CITY OF ALBUQUERQUE

**RE: Lot 26 Block 6 Unit 22 Volcano Cliffs SAD 228
6209 Papagayo NW
Grading and Drainage Plan
Engineers Stamp Date 2/22/18 (D10D003B14)**

Based upon the information provided in your submittal received 9/26/17, this plan cannot be approved for Grading Permit until the following comments are addressed.

ENGINEER'S SEAL  2/22/18 DAVID SOULE P.E. #14522	6212 CAMINO ALTO CT NW WALTON RESIDENCE	DRAWN BY WCVJ DATE 2-22-18
	GRADING AND DRAINAGE PLAN	21844-LAYOUT-1-05-18
 Rio Grande Engineering 1606 CENTRAL AVENUE SE SUITE 201 ALBUQUERQUE, NM 87106 (505) 872-0998		SHEET #
		JOB # 21844

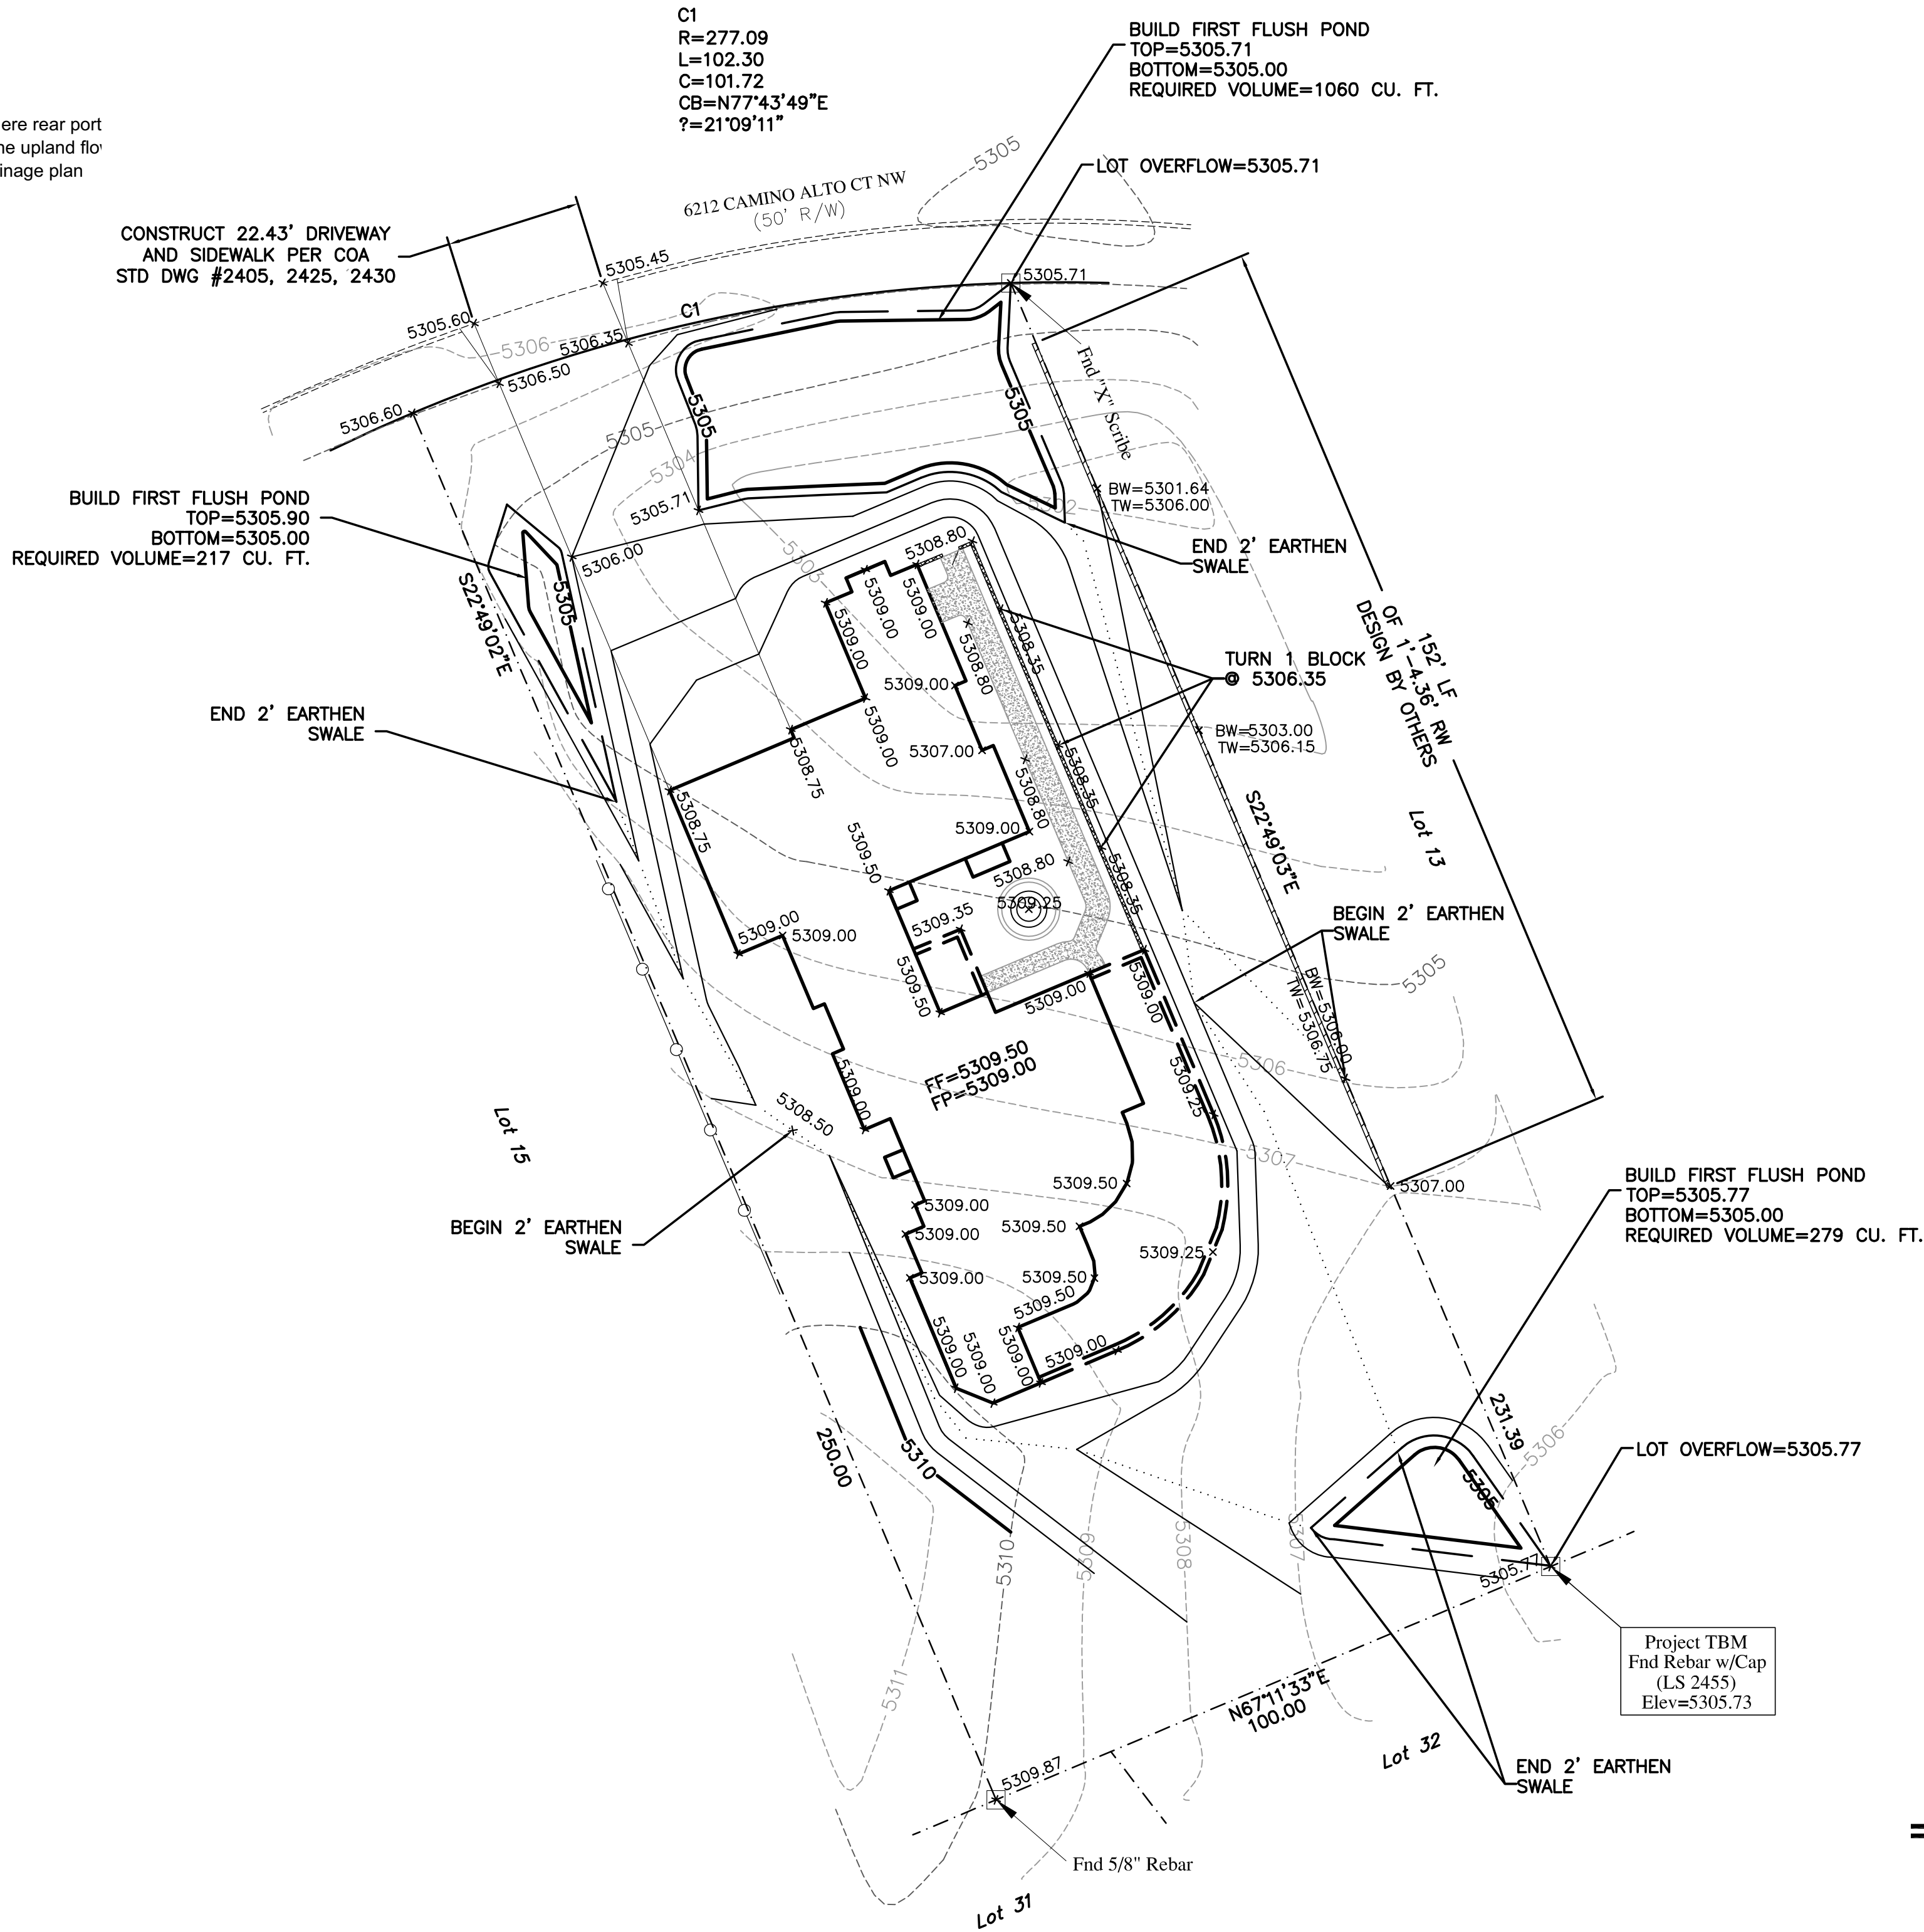
- Building Pad level too high.
- Show how runoff will make it to the pond.

DUE TO ROCK THE OWNER RAISED THE PAD 2. THIS IS A REVISED GRADING PLAN
AND A PAD CERT FOR NEW PLAN
